SUBJECT: PEACH BOTTOM ATOMIC POWER STATION, UNITS 2 AND 3 - STAFF ASSESSMENT OF INFORMATION PROVIDED PURSUANT TO TITLE 10 OF THE *CODE OF FEDERAL REGULATIONS* PART 50, SECTION 50.54(f), SEISMIC HAZARD REEVALUATIONS RELATING TO RECOMMENDATION 2.1 OF THE NEAR-TERM TASK FORCE REVIEW OF INSIGHTS FROM THE FUKUSHIMA DAI-ICHI ACCIDENT (TAC NOS. MF3866 AND MF3867)

STAFF ASSESSMENT BY THE OFFICE OF NUCLEAR REACTOR REGULATION

RELATED TO SEISMIC HAZARD AND SCREENING REPORT

PEACH BOTTOM ATOMIC POWER STATION, UNITS 2 AND 3

Figure 3.3-1 Plot of Staff's and Licensee's Base Case Shear-Wave Velocity Profiles

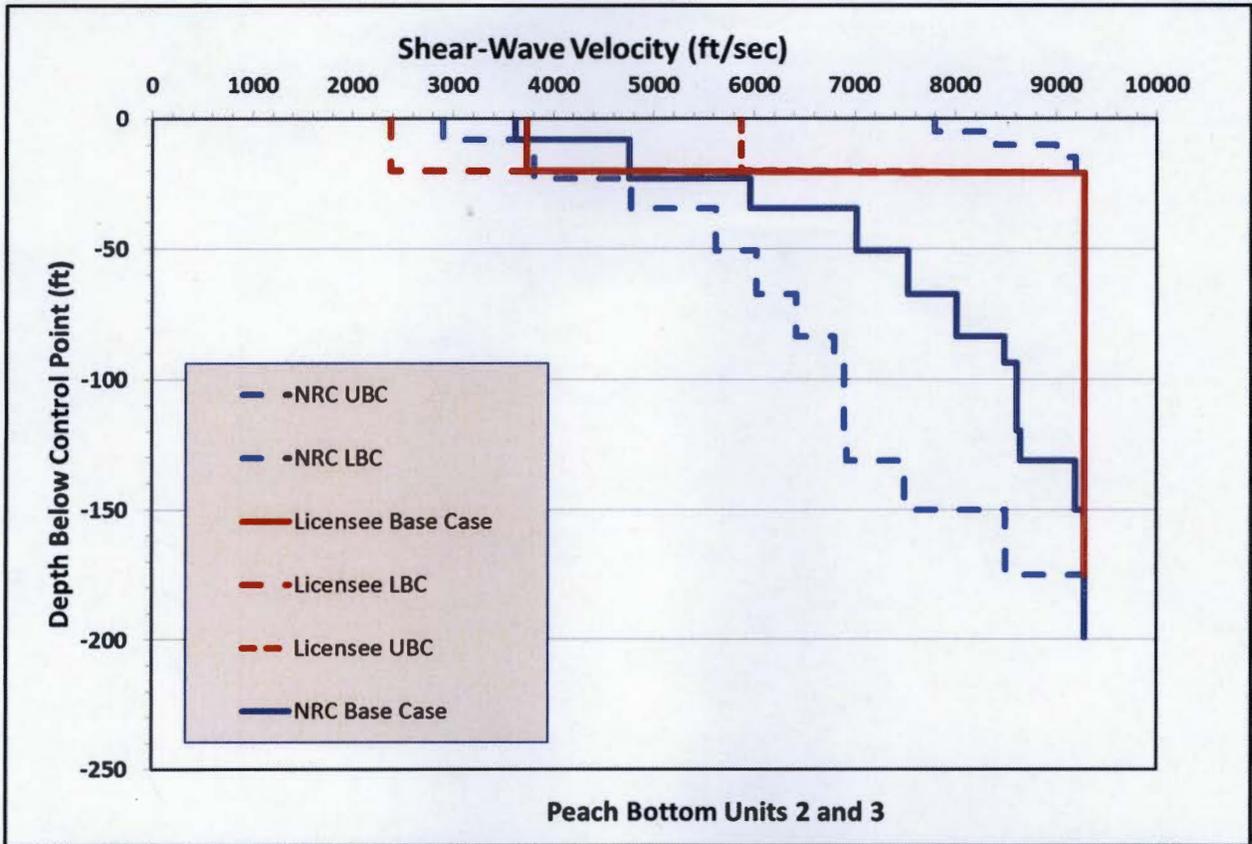
To capture the uncertainty in the shear wave velocities at the Peach Bottom site for the approximately 20 ft (6.1 m) of weathered rock, the licensee developed three base case profiles. For the best estimate or base case shear-wave velocity profile, the licensee used a shear-wave velocity of 3,742 ft/s (1,141 m/s). To develop the upper and lower base case profiles, the licensee used a standard deviation of 0.35 (corresponding to a scale factor of 1.57 for the 10<sup>th</sup> and 90<sup>th</sup> percentile values) to estimate the lower and upper base case shear-wave velocity profiles. These estimated velocities ranged from 2,383 to 5,874 ft/sec (728 to 1,790 m/s) in the upper 20 ft (6.1 m). Figure 3.3-1 in this assessment shows the licensee's shear-wave velocity profile for each of the three base cases.

As discussed above, no in-situ seismic wave velocities are available in the Peters Creek schist at the Peach Bottom site. Laboratory measurements of compressional-wave velocities and unit weights were obtained from core samples (using shock-scope tests) from several boreholes at selected depths (documented in UFSAR Table 2.5.2). The staff independently developed shear-wave velocity profiles based on an analysis of the available data and augmented by additional reference material. The staff concluded that the average of the measured near-surface compressional-wave velocities in the moderately weathered schist is approximately 7000 ft/sec (2134 m/s). Based on Poisson's ratio values appropriate for schist at near-surface conditions (Bourbie, et al. (1987), Sheriff and Geldart (1995)), the staff concluded a shear-wave velocity of 3620 ft/sec is appropriate for the base case profile at the control point elevation. This value is similar to that cited in the General Atomics study and the value used by the licensee of 3742 ft/s (1141 m/s). To develop upper and lower base case profiles, the staff used the observed range of compressional wave velocities and an appropriate range of Poisson's ratio for these materials (0.28 to 0.34). The lower and upper profiles used in the NRC staff assessment have shear wave velocities of 2901 ft/sec (lower base case) and 8185 ft/sec (upper base case), respectively. Rather than using a single shear wave velocity value and a thickness of 20 ft (6.1 m) for the depth to reference or base rock, the staff's base case profiles used the velocity templates described in Appendix B of the SPID to more realistically model the subsurface of the Peach Bottom site. Figure 3.3-1, in this assessment, compares the staff's base case profiles to those developed by the licensee.

Figure 3.3-2 Comparison of the Licensee's and NRC Staff's Median Amplification Functions and Uncertainties (Sigma Ln(AF)).

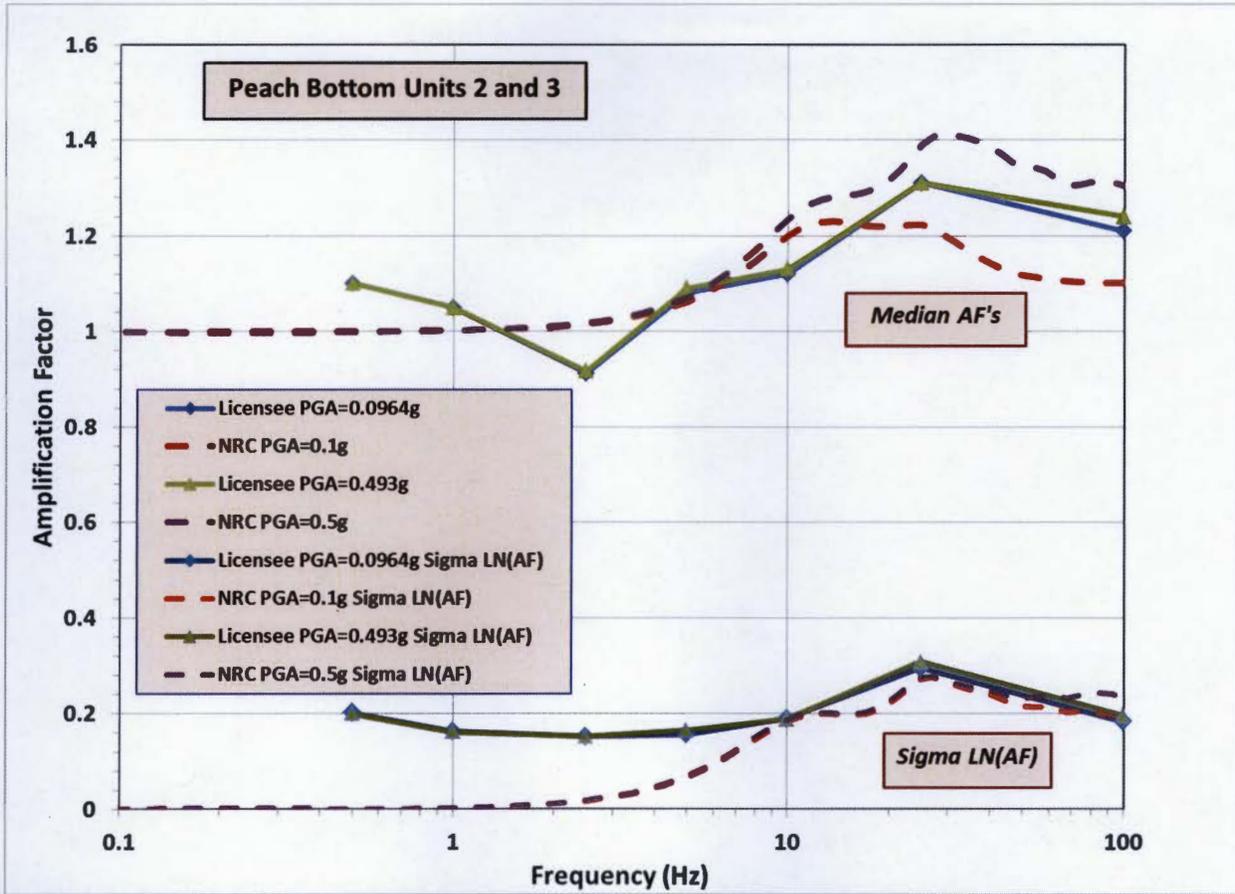
Figure 3.3-2 compares the staff's and licensee's median site amplification functions and uncertainties for two of the eleven input loading levels. The results are very similar with a modest site amplification of about 1.2 to 1.4 at about 30 Hz. As shown in Figure 3.3-4, the minor differences in the site response analyses between the licensee and staff have a minimal impact on the resulting control point seismic hazard curves. Appendix B of the SPID provides guidance for performing site response analyses, including capturing the uncertainty for sites with less

Figure 3.4-1 Comparison of the Staff's GMRS with Licensee's GMRS and the Peach Bottom Units 2 and 3 SSE.

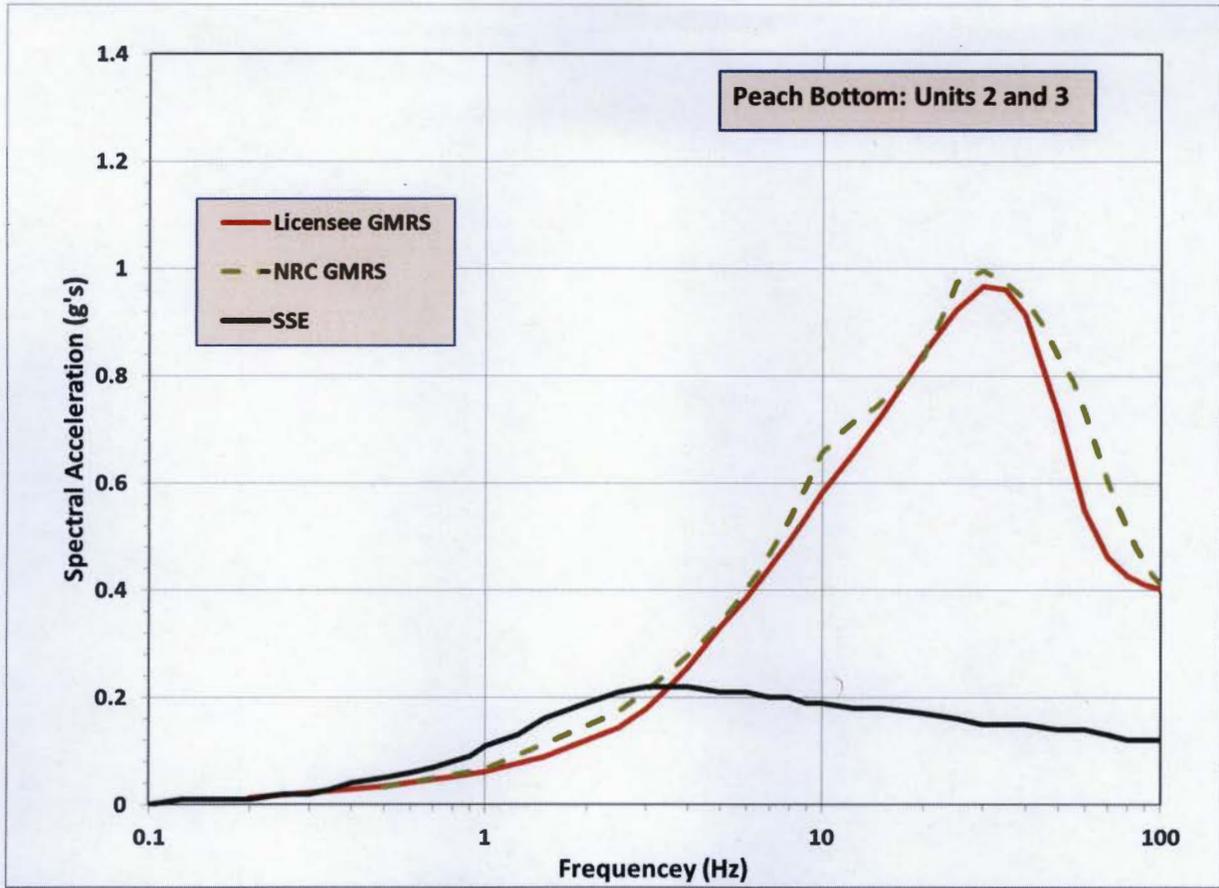
The staff independently obtained the  $10^{-4}$  and  $10^{-5}$  UHRS using the results of its confirmatory PSHA and site response calculations described in Sections 3.2 and 3.3 of this staff assessment, respectively. As shown in Figure 3.4-1 of this assessment, the licensee's GMRS shape is very similar to that calculated by the staff. As described above in Section 3.3, the staff concludes that these minor differences over the higher frequency range are primarily due to the differences in assumptions made in the site response analyses performed by the licensee and staff. The staff concludes that these differences are acceptable because the licensee followed the guidance provided in the SPID with respect to both the PSHA and site response analysis for the Peach Bottom site.

In reaching this determination, the staff confirmed the licensee's conclusion that the licensee's GMRS for the Peach Bottom site exceeds the SSE above approximately 4 Hz to the 100 Hz range. As such, Peach Bottom, Units 2 and 3 screens in for a seismic risk evaluation, SFP evaluation, and high frequency confirmation, which the licensee indicated would be performed as part of its seismic risk evaluation. NRC review and acceptance of Exelon's ESEP interim evaluation and seismic risk evaluation with the high frequency and SFP evaluation (i.e., Items (4), (6), (8), and (9)) for Peach Bottom, Units 2 and 3 will complete the items requested in Enclosure 1 of the 50.54(f) letter.
